Service Information

Category T	Repair Guidance	Ref. No. R090/13	Page 1 of 3
Coverage <input type="checkbox"/> Distributor only <input checked="" type="checkbox"/> Please inform your dealers		Date Issued November 7, 2013	
Please convey this information to your <input type="checkbox"/> Director <input checked="" type="checkbox"/> General Manager <input checked="" type="checkbox"/> Warranty Dept. <input checked="" type="checkbox"/> Parts Dept. <input checked="" type="checkbox"/> Training Dept. <input checked="" type="checkbox"/> Field Rep.		Date Revised	
Applicable Model Mazda6 (GJ) Sedan		Applicable Countries or Specifications Europe, Russia

Subject: Water Entry into Trunk Lid Light at high pressure car washing

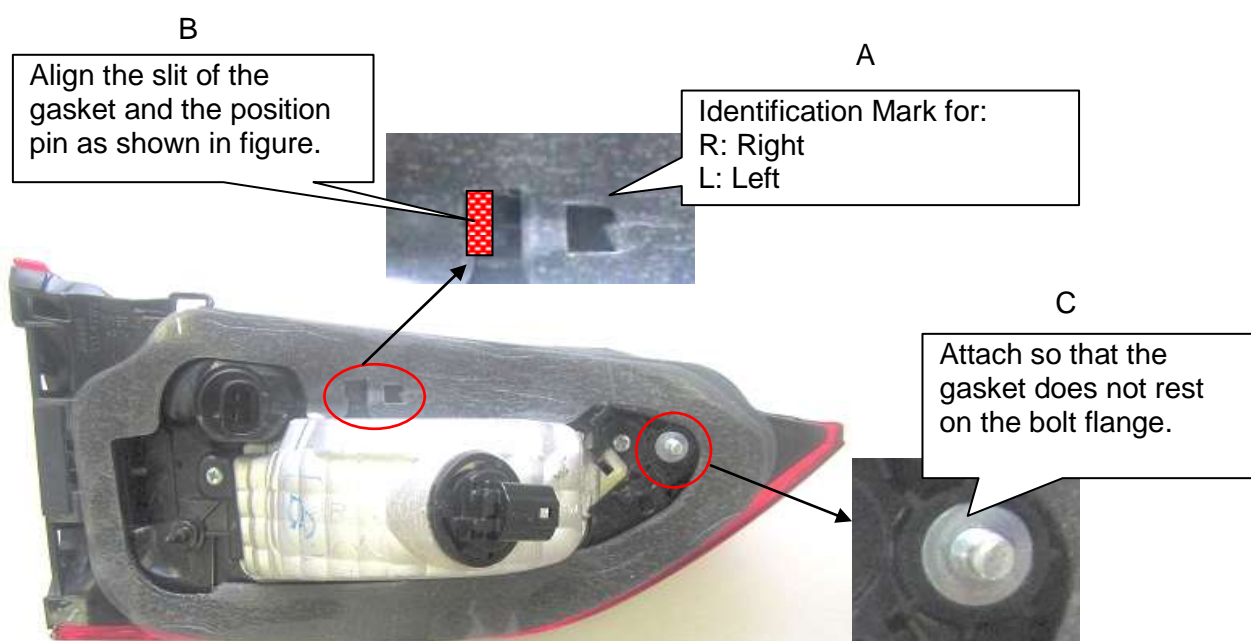
4. Attach the gasket (modified service part) to the new trunk lid light.
Note: A double-sided adhesive tape is attached to both sides of the gasket. Peel off the release paper before attaching the gasket.
Note: Attach the gasket taking note of information A to C in the figure.
Note: It is not necessary to install the packing.
